SUBJECT: Comment Response Memorandum

PROJECT: Larson Automotive Group – Building 300 – Permit #PRCCP20220092

MC Job No: LARS-0001

<p>CITY OF PUYALLUP PUBLIC WORKS WATER DIVISION</p>	<p>RECORDS REQUEST 21-1277 WATER AROUND 300 RIVER ROAD</p>	SCALE AS SHOWN
		09/23/2021
<p>COP:PW\WATER\S_MAINT\PDF\QSEC\PG084\REQUEST HEO AT 300 RIVER RD</p>

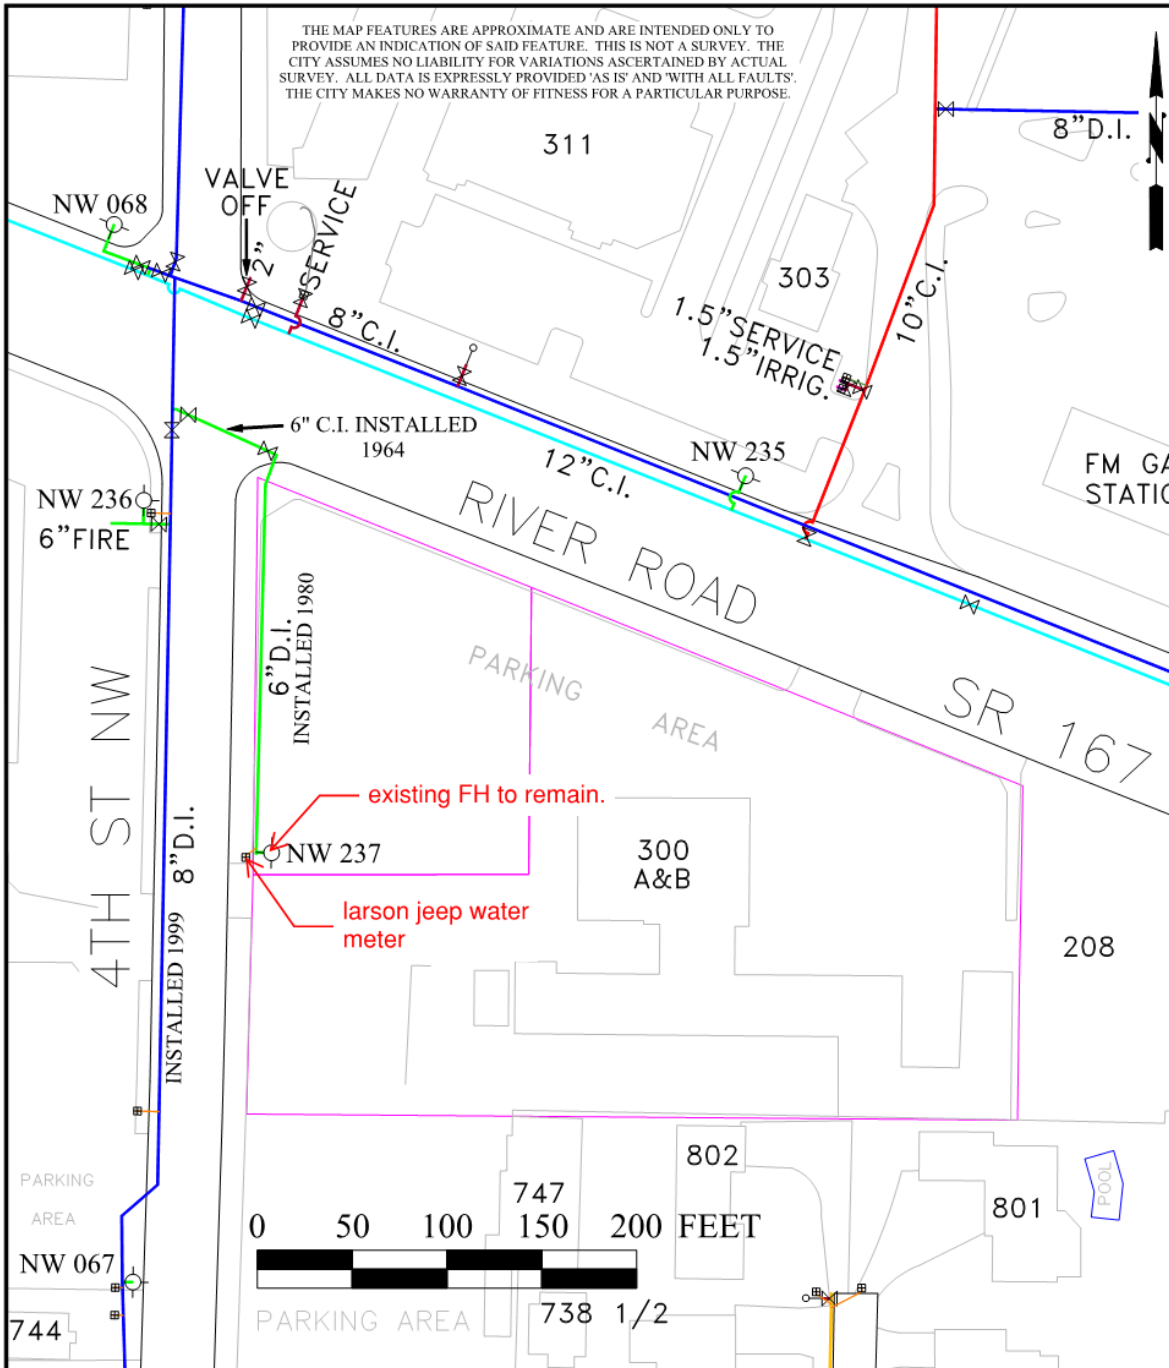
Civil Sheet C5.0: Replace relocated water service back to water main. Add City Standard detail 03.03.01 to plan set.

MC: The existing water meter is connected to the existing 6-inch water main that terminates at the fire hydrant. We propose keeping the existing tap to the 6-inch water main and relocating the water meter slightly to the south to allow for a 2" or smaller DCVA to be constructed upstream of the meter. Please refer to the attached Water Service Map. Standard Detail 03.03.01 has been added to the plans.
